# Access Compliance Report Public Rights-of-Way (Curb Ramps)

**Main Street:** GILBERT\_ST      **Cross Street:** CHANTICLEER\_RD      **Location:** NW

**ADA ID:** RPRK210923123226      **Ramp Type:** Type 4 - Parallel      **Initial Pass/Fail:** Pass      **Overall Compliance:** No      **Severity Score:** 6

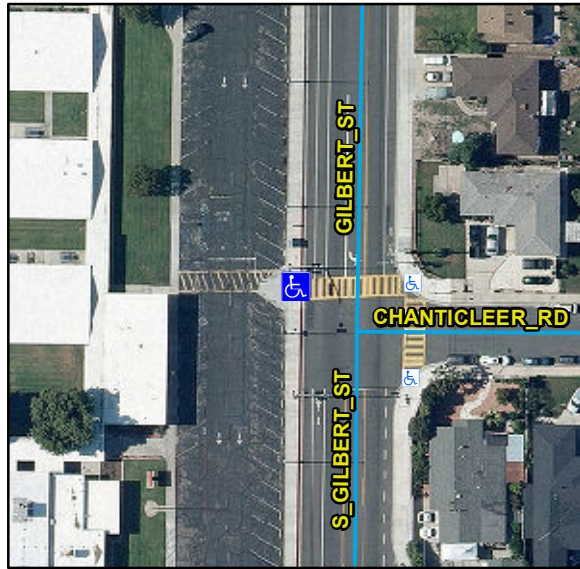
Crossing 1 Slope (%)	4.7		Crossing 2 Slope (%)	N/A
	Crossing 1 Cross Slope (%)	0.2		Crossing 2 Cross Slope (%)	N/A
Yes	Gutter Ponding	No	Yes	Curb Slope	7.6
Yes	Gutter Lip Height (in)	0		Road Run Slope (%)	N/A
Yes	Gutter Run Slope (%)	0.4		Road Cross Slope (%)	N/A
No	Gutter Cross Slope (%)	5.6	Yes	Perpendicular Joint Present	Yes
Yes	Overall Surface Condition	Acceptable			
	Cross Gutter Present?	No		Spandrel Present?	No
	Replace Cross Gutter?	N/A		Replace Spandrel?	N/A

**Possible Solutions:**  
**Remove & Replace Landing. Remove & Replace Gutter.**
